Sheet #	Content	Sheet #	Content
01.	Table of Content	33.	WTR3925
02.	Revision History	34.	TXM_MMMPA
03.	Block Diagram	35.	PRX_DUPLEXER
04.	SM6115_CONTROL	36.	DRX_SAW
05.	SM6115_GPIO	37.	QET4101
06.	SM6115_EBI01	38.	WCN3950
07.	SM6115_MIPI-CSI&DSI	39.	WIFI_GPS
08.	SM6115_WCSS&RF		
09.	SM6115_PWR_1		
10.	SM6115_PWR_2		
11.	SM6115_PWR_3		
12.	SM6115_DECAPS		
13.	SM4250_GND		
14.	PM4250_HK_IO		
15.	PM4250_BUCKs_S1-S8		
16.	PM4250_LDOs		
17.	PMI632_Control		
18.	PMI632_Charger		
19.	PMI632_LCD&VIB&LED&Flash		
20.	eMMC&LPDDR4		
21.	eMMC&LPDDR4_Power		
22.	Battery&USB_IF		
23.	Audio_codec		
24.	EAR&Smart_PA		
25.	CAMERA_IF		
26.	SENSOR		
27.	SIM_TF		
28.	KEY&TEST_POINT		
29.	SUB_CONN		
30.	Display_IF

Title	<b>44.Capsensor</b>	REV: V0.1
DOCUMENT NO.:	<b>LLDM328E1-3_0421-2030</b>	Size B
DEPARTMENT:	DEPARTMENT	DESIGNER: DESIGNER
<b>龙旗科技 LONGCHEER Since 2002</b>		
Date:	Wednesday, March 02, 2022	Sheet 44 of 53

Title		
Size C	Document Number	Rev
<Doc>	WEDNESDAY, MARCH 02, 2022	<Rev>
Date:	Sheet 5 of 53	<Code>

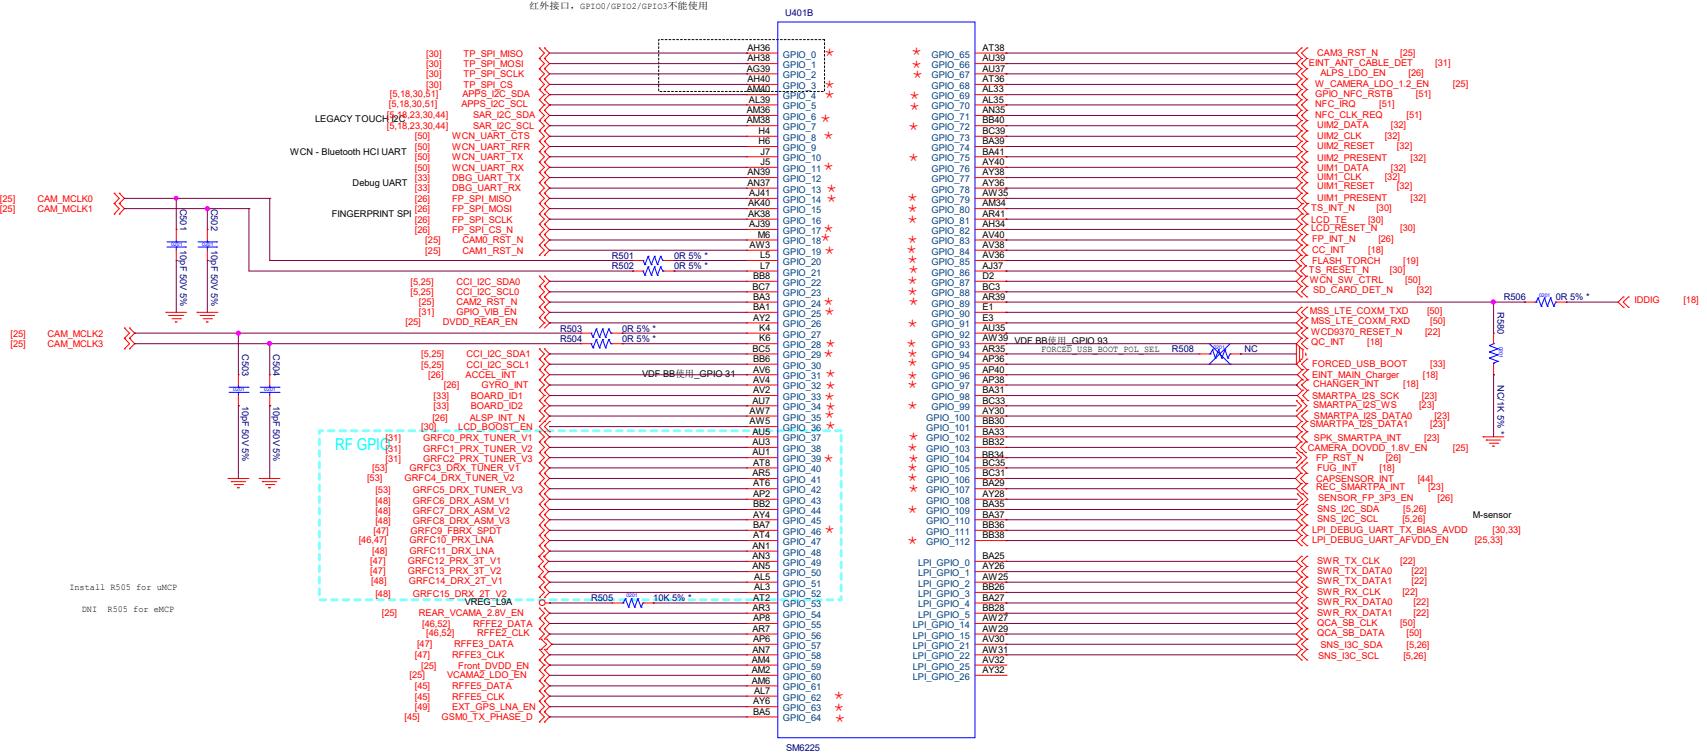
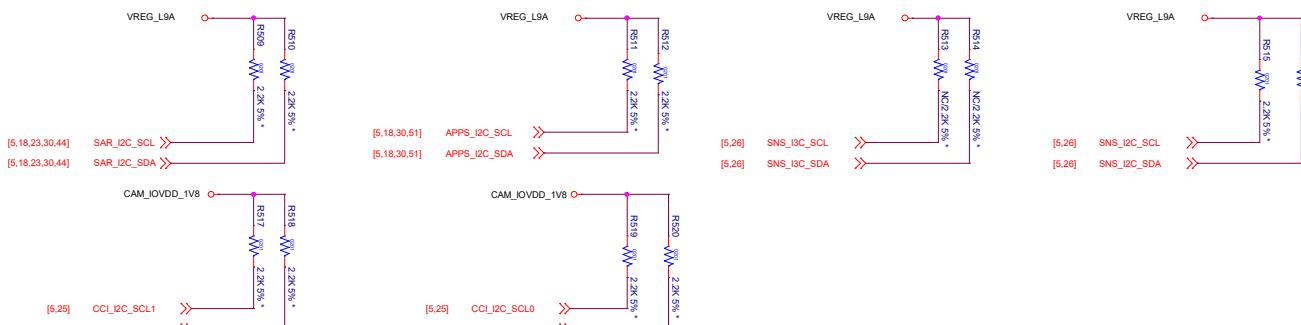
GPIO\_89 should be Pulled Down or pulled up to Vreg\_L9A through 1K resistor when 3rd party charger is used. 1K Pull Down on GPIO\_89 is required for eDL mode USB enumeration and USB Port 0 will be selected in eDL mode for code download.

Title <Title>		
Size C	Document Number <Doc>	Rev <RevCode>
Date: Wednesday, March 02, 2022	Sheet 15 of 53

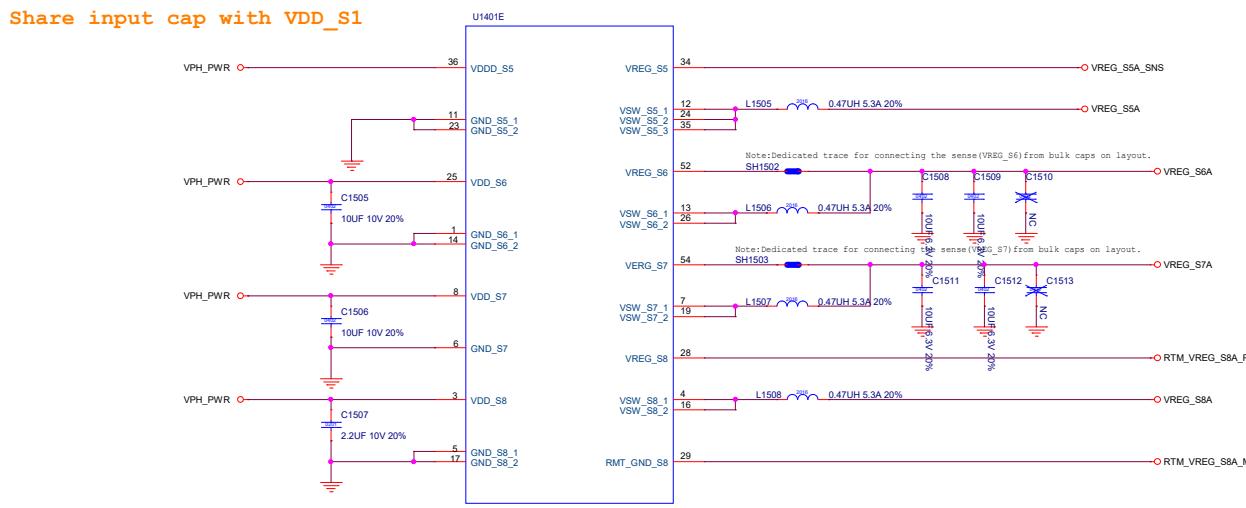
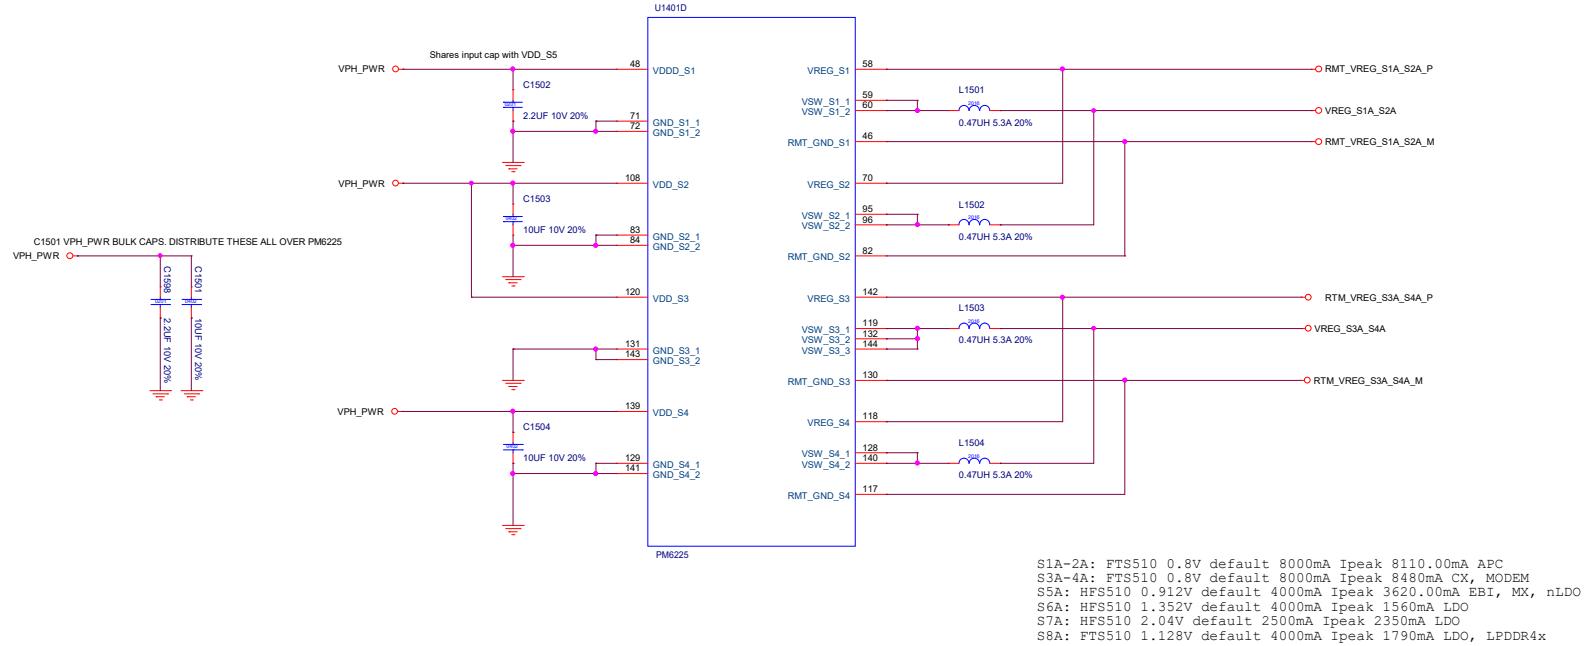
PM6225 part looks fine, but one important point is that GPIO1 should not be used for other purpose. It is part of power on sequence to enable eLDO for USB SS\_DP please refer 80-26896-41 document
